MEMO

TO: Lashta Haidari, Steven Findlay
FROM: Ody Murlianto, Richard West, Ryan Miller
SUBJECT: Meriton Dee Why Review of Traffic Matters
OUR REF: 2196969A-ITP-MEM-RPT RevA.docx
DATE: 28 March 2017

Northern Beaches Council has engaged WSP | Parsons Brinckerhoff to undertake a review of the Traffic Impact Assessment undertaken to support the Development Application submission for the subject development.

Parking Level 2 - Swept Path Analysis
B85 & B99 Vehicle

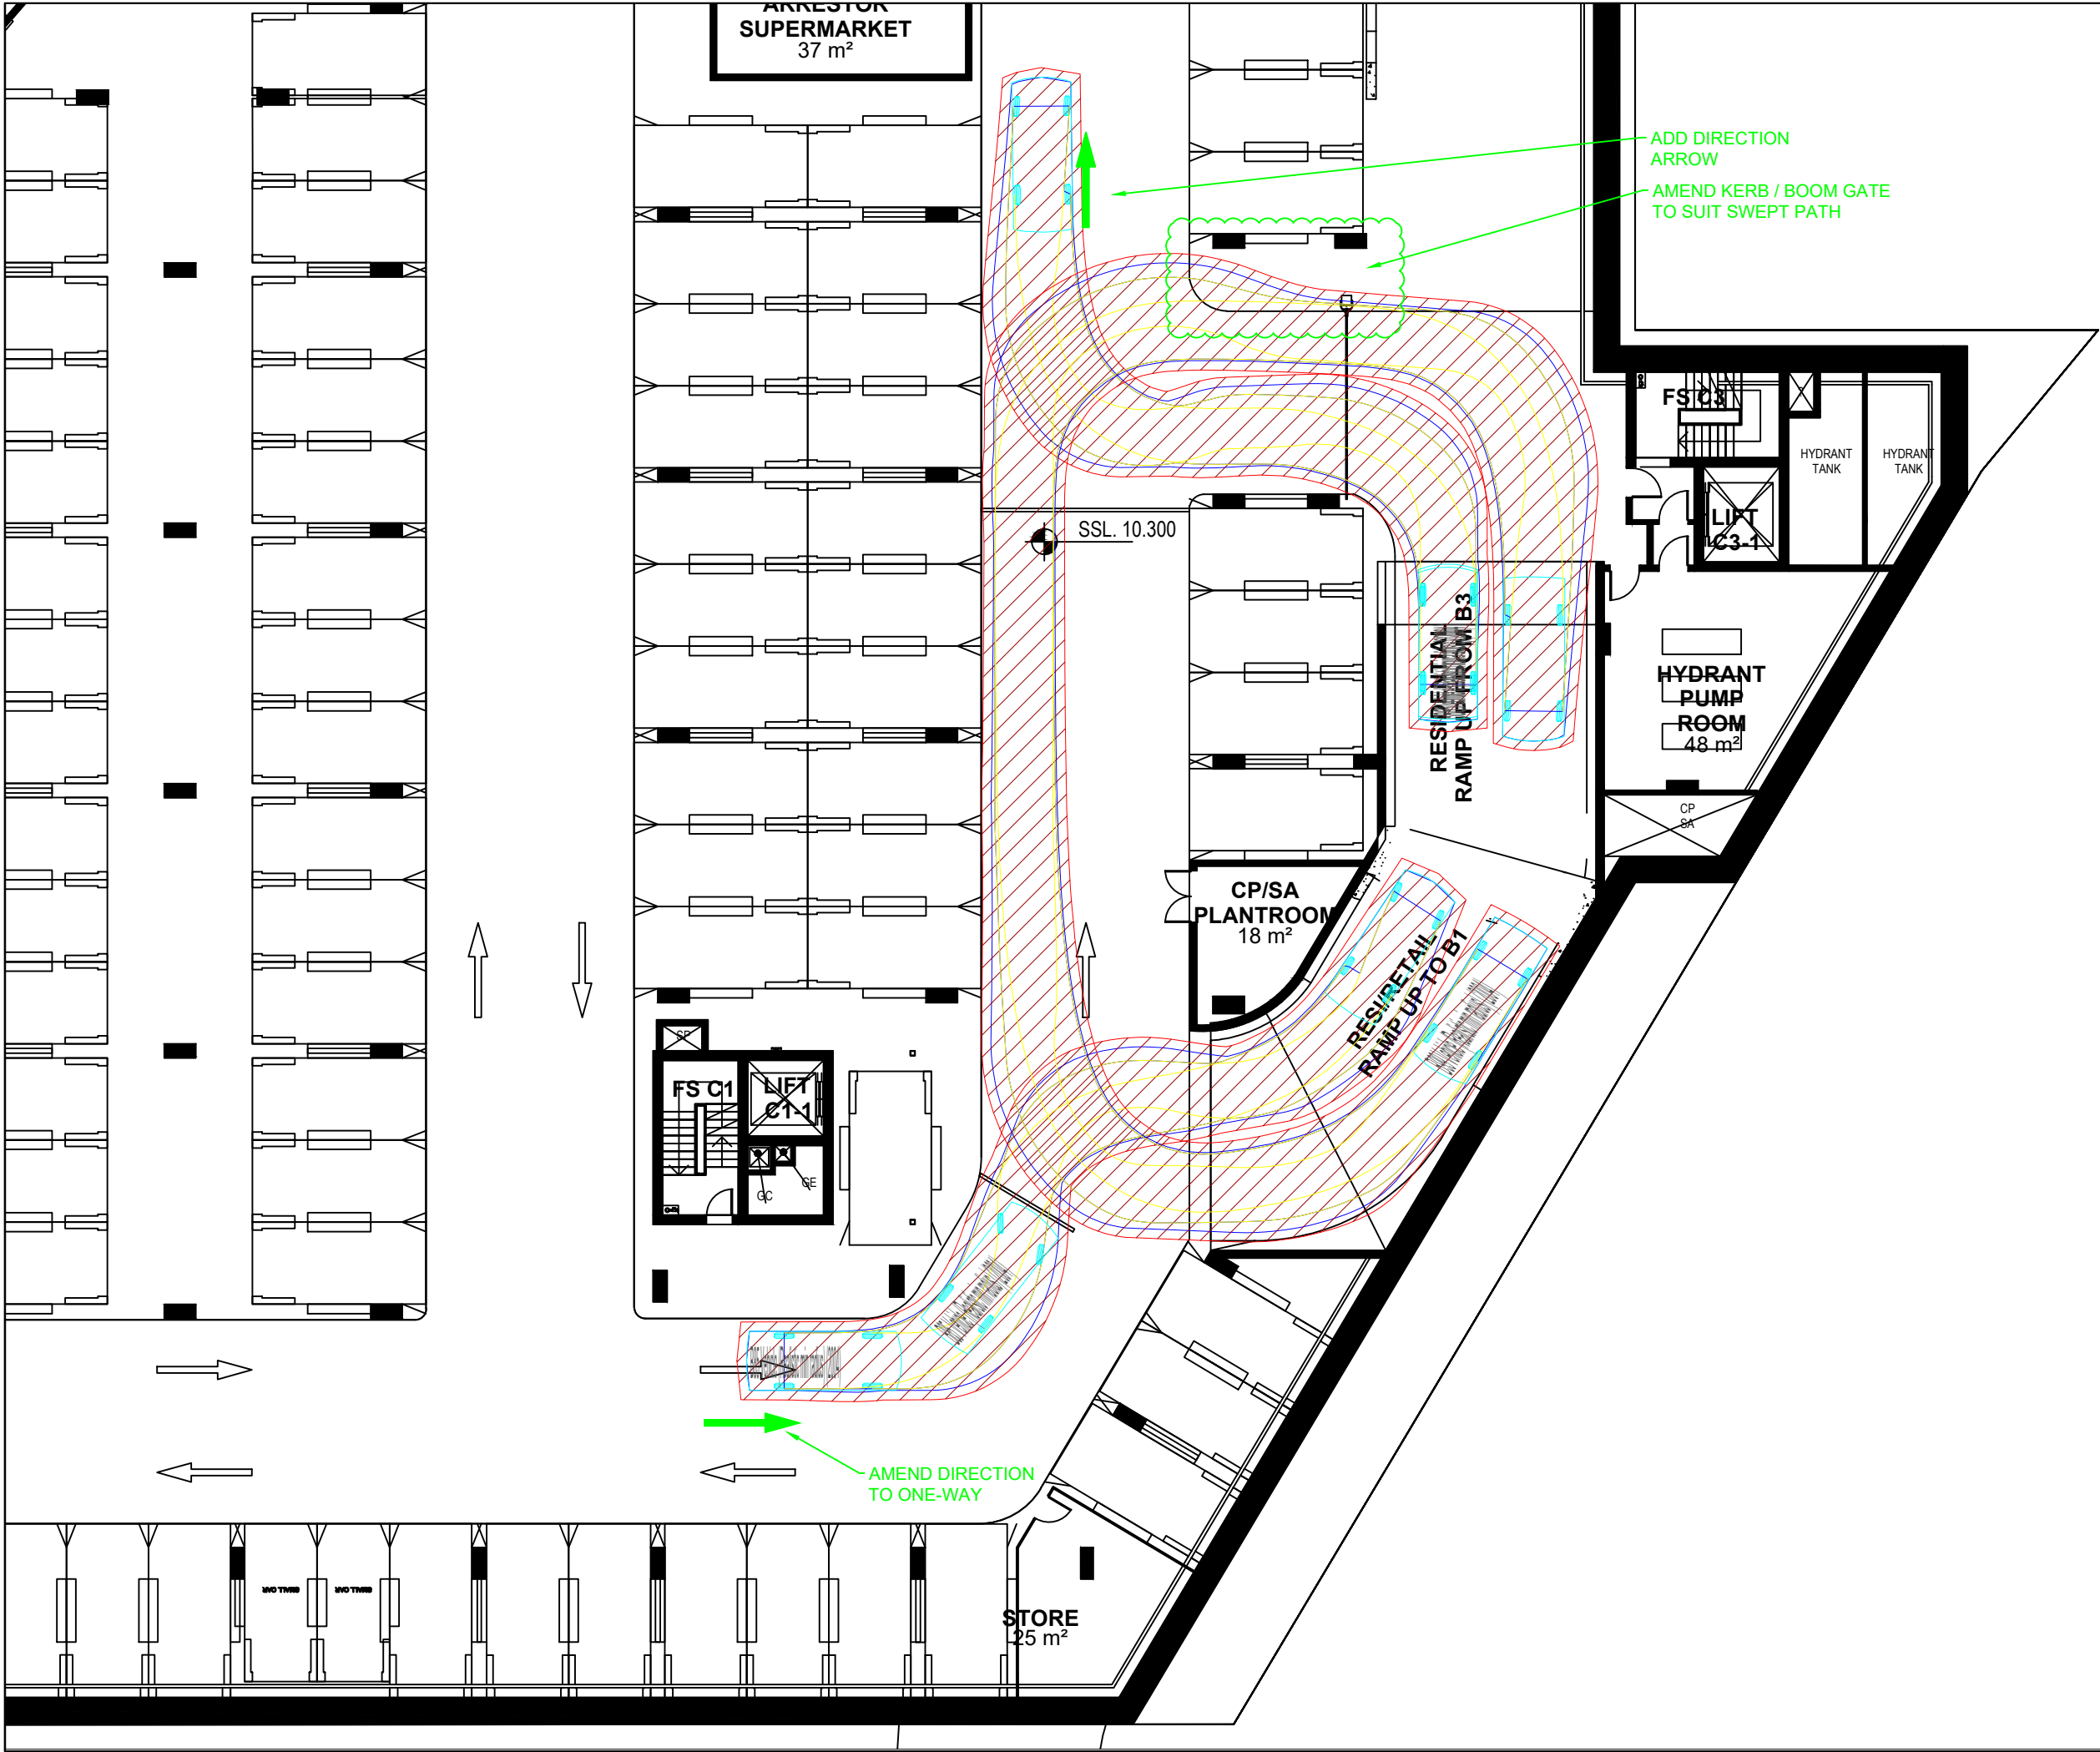
CUT-BACK KERB TO
SUIT SWEEP PATH

THIS PARTICULAR WALL SHOULD BE
SEE-THROUGH TOWARDS THE BOTTOM
OF THE RAMP SO THAT A CAR STOPPED
BEHIND THE PROPOSED STOP LINE
CAN OBSERVE VEHICLES TRAVELLING DOWN
THE RAMP.
